ADDENDUM NO. 05

**High School Addition & Renovation
Jr. High Addition & Renovation
Intermediate School Controls Renovations
Primary School Controls Renovations
Softball Concessions
Ellettsville, IN 47429**

ADDENDUM NO. FIVE

**Richland-Bean Blossom CSC
Additions and Renovations**

MECHANICAL
SCHEDULES

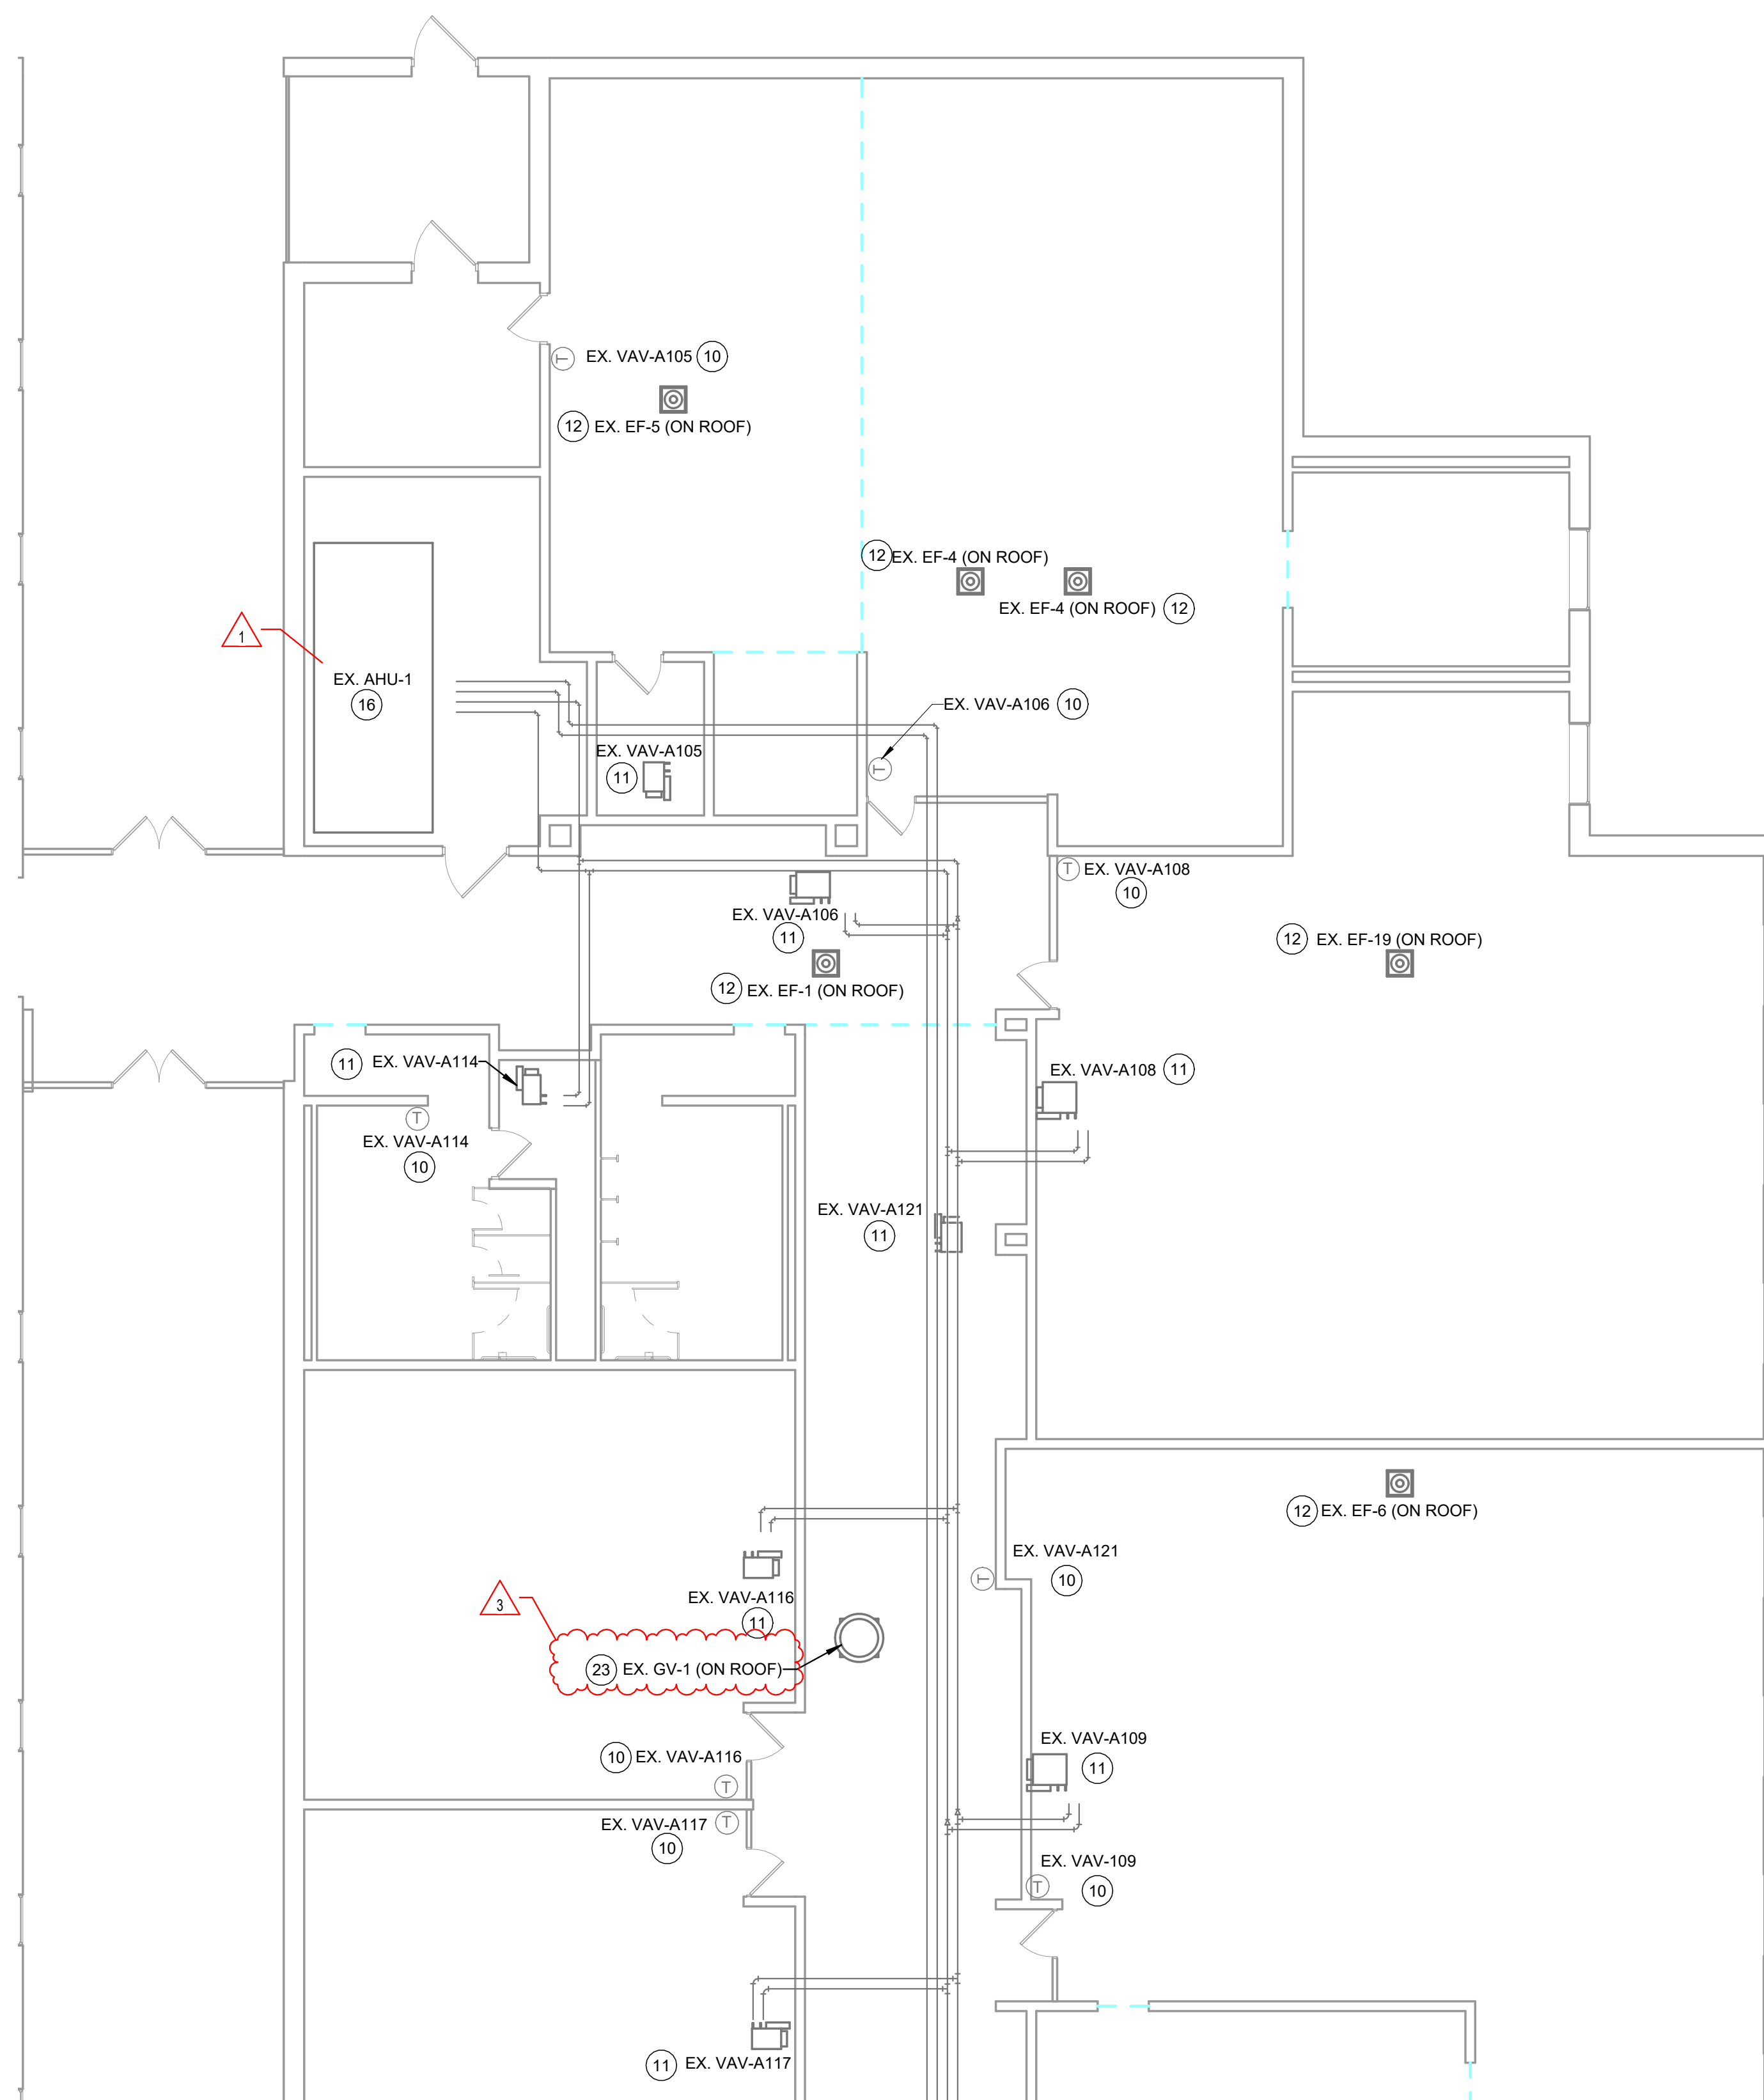
2. Drawing M-602
 - a. UPDATED EX. VFD SCHEDULE

EXISTING AHU VFD SCHEDULE		
TAG	HP	VOLTAGE / PHASE
EX. AHU-1	25	480V / 3PH
EX. AHU-2	25	480V / 3PH
EX. AHU-3	10	480V / 3PH
EX. AHU-4	40	480V / 3PH
EX. AHU-5	20	480V / 3PH
EX. AHU-6	5	480V / 3PH
EX. PHU-1	10	480V / 3PH
EX. PHU-2	7.5	480V / 3PH
EX. AHU-7	7.5	480V / 3PH
EX. AHU-8	5	480V / 3PH

MP101A1

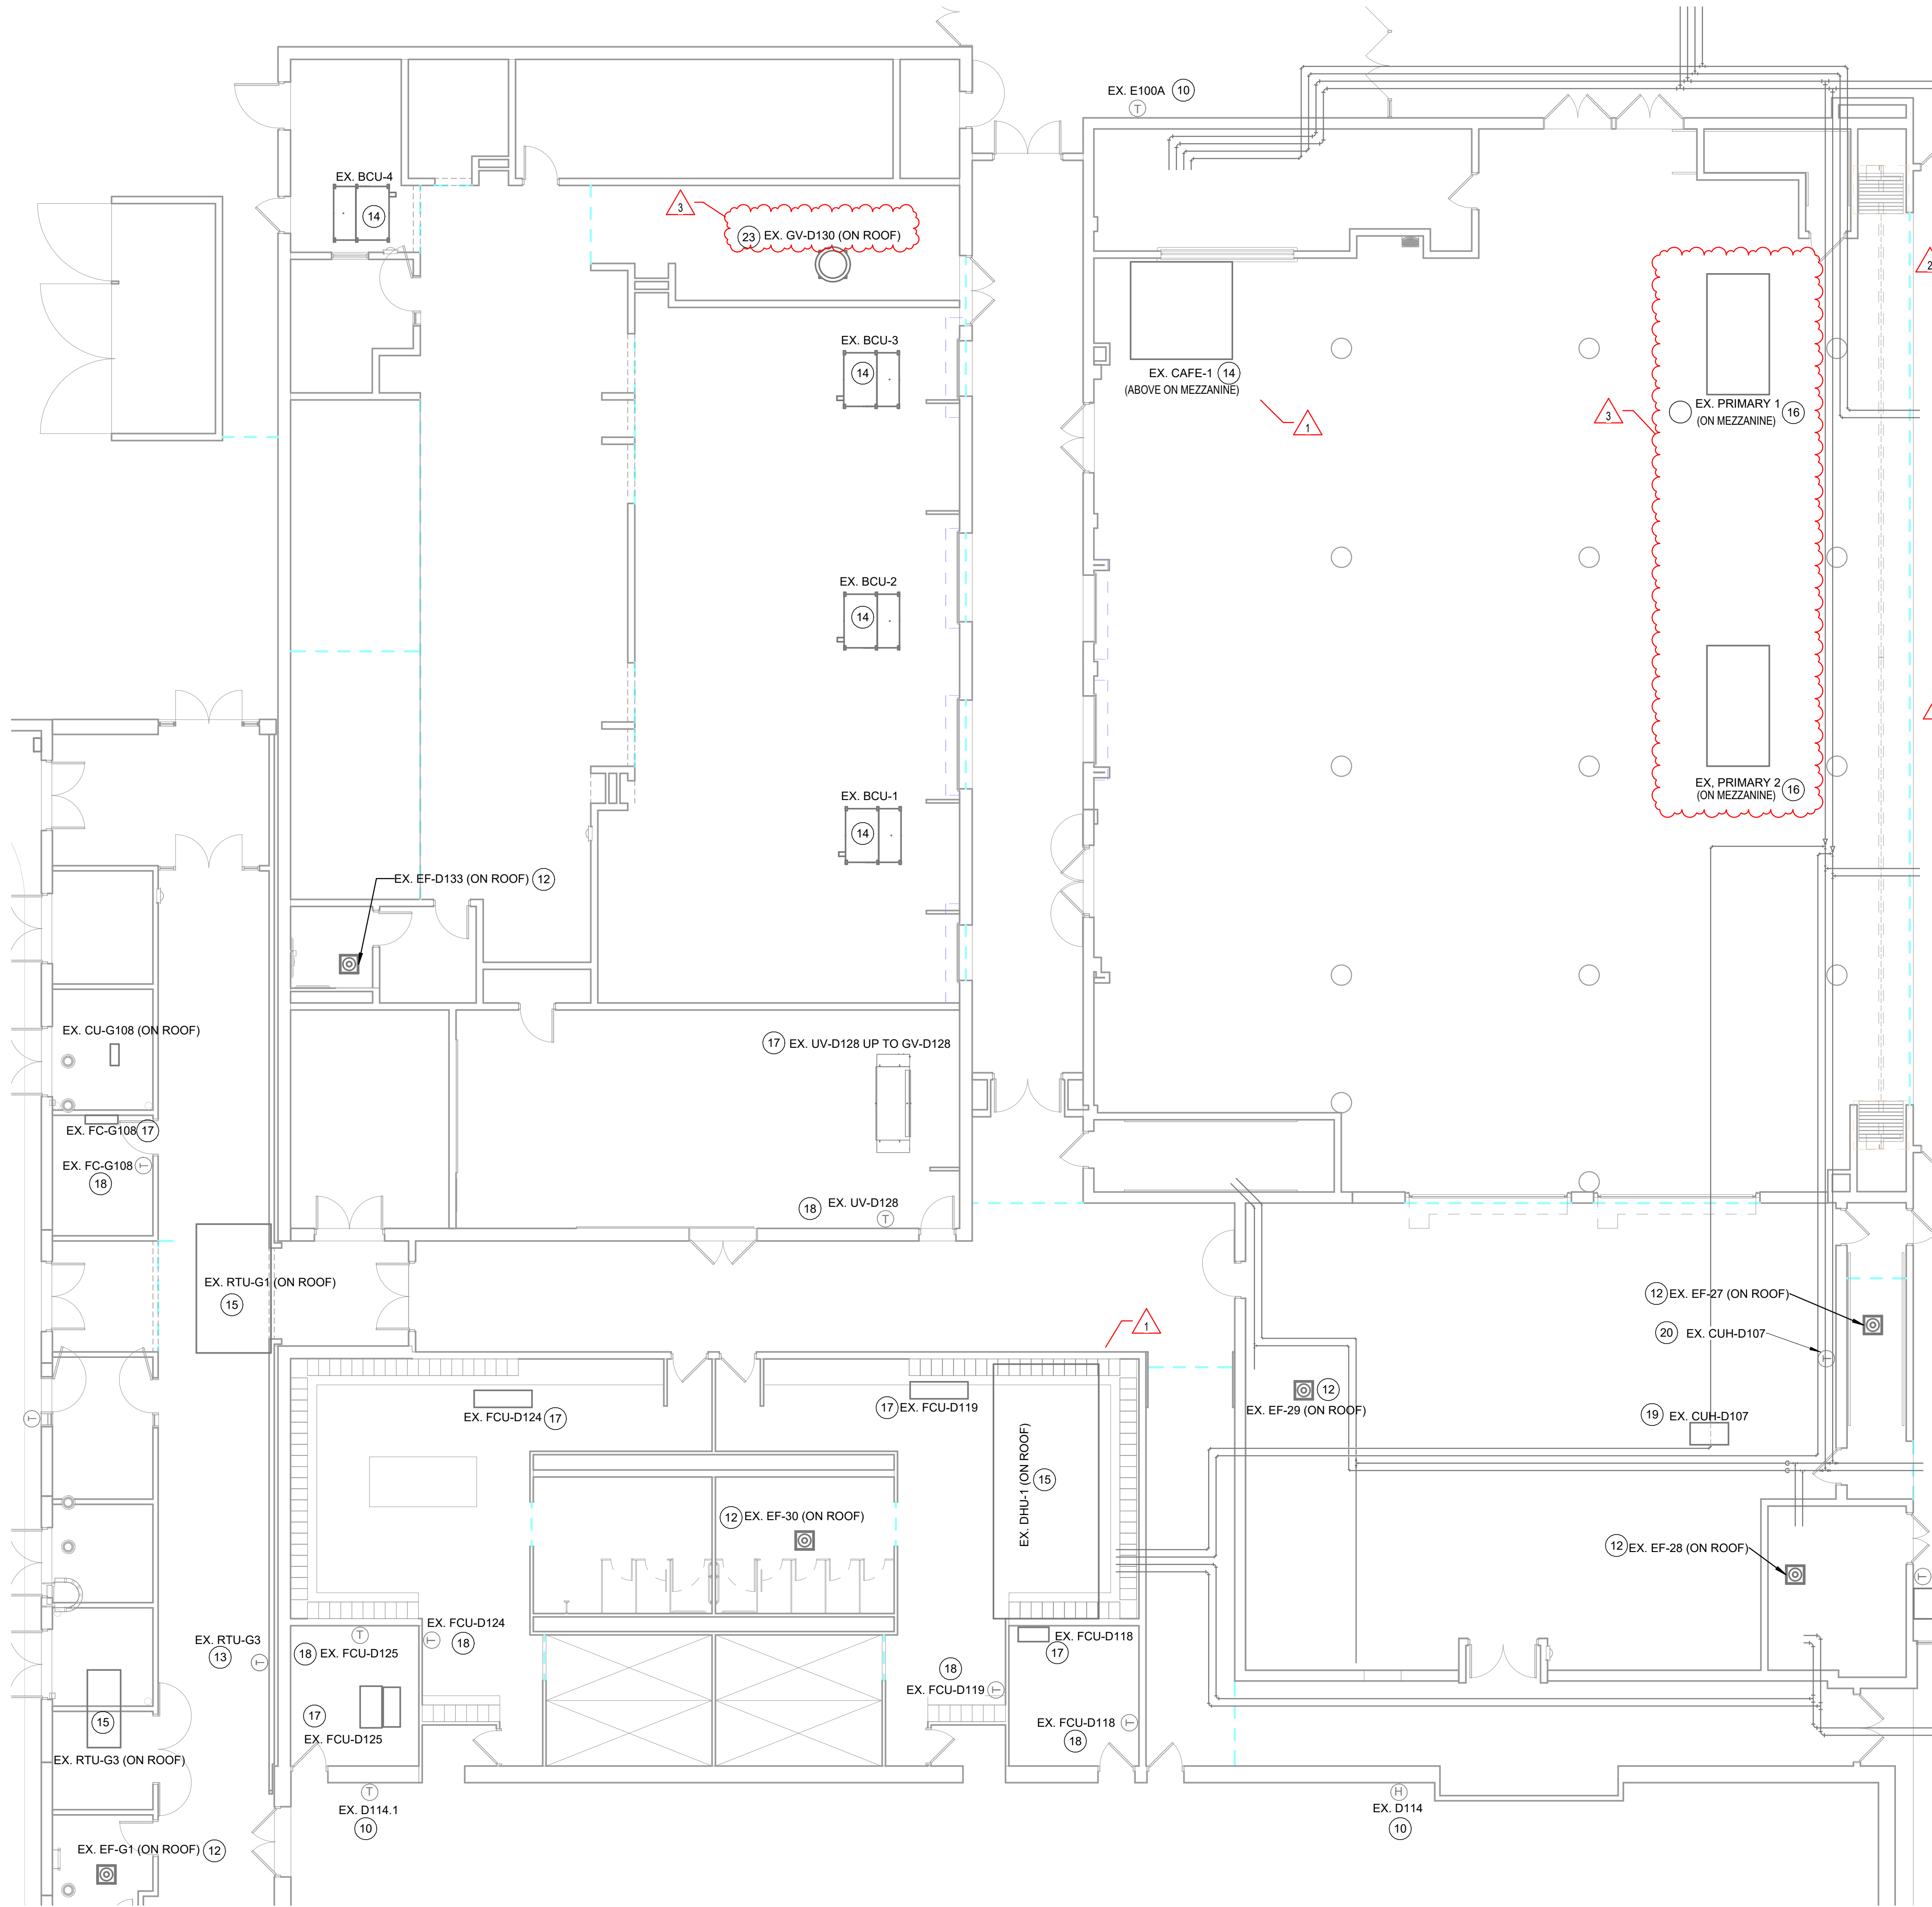
1. Drawing MP101A1
 - a. REVISED NOTE 16
2. Drawing MP101D1
 - a. ADDED PRIMARY UNITS 1 & 2
3. Drawing M-601
 - a. UPDATED EX. VFD SCHEDULE

- 9. ROUTE 1-1/4" HEADER TO DOWN. HWS & HWR TO VAV-106.1 & 106.2 IS 1" HWS & HWR. SEE DETAIL 13 ON M-501.
 - 10. REMOVE EXISTING SPACE TEMPERATURE SENSOR AND COMMUNICATION WIRING COMPLETE. PROVIDE NEW TEMPERATURE SENSOR AND COMMUNICATION WIRING TO NEW DDC CONTROLLER AT VAV TERMINAL UNIT BEING CONTROLLED.
